SERVICE TECHNICAL INFORMATION

ONE POINT REPAIR

UTSUNOMIYA, SEP. 20, 1998
REF. NO.: SI-98-026
CUSTOMER RELATIONS & SERVICE DIV.

MODEL : HS-JX808/807/804

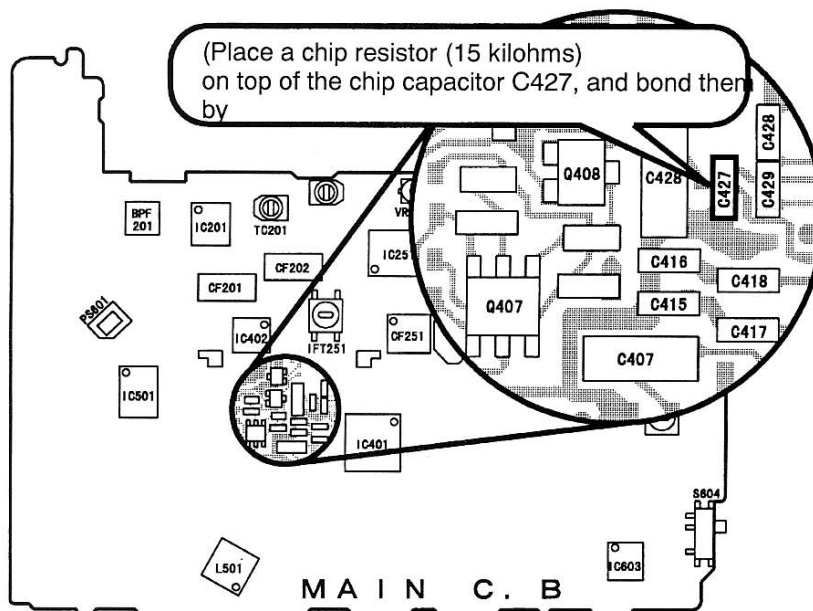
SUBJECT : Noise is produced when DSL is on.

CONTENTS : With the DSL turned on, low frequency noise may be heard when the sound level is small or when there is no sound. If such a low frequency noise is pointed out by the customer, perform the following remedy:

REMEDY : Place a chip resistor (15 kilohms) on top of the chip capacitor C427 (0.15 microfarad), and bond them by soldering.

Ref.	Parts name	Parts No.	Remarks
R456	C-RES, U 15K-1/16WJ	88-108-153-080
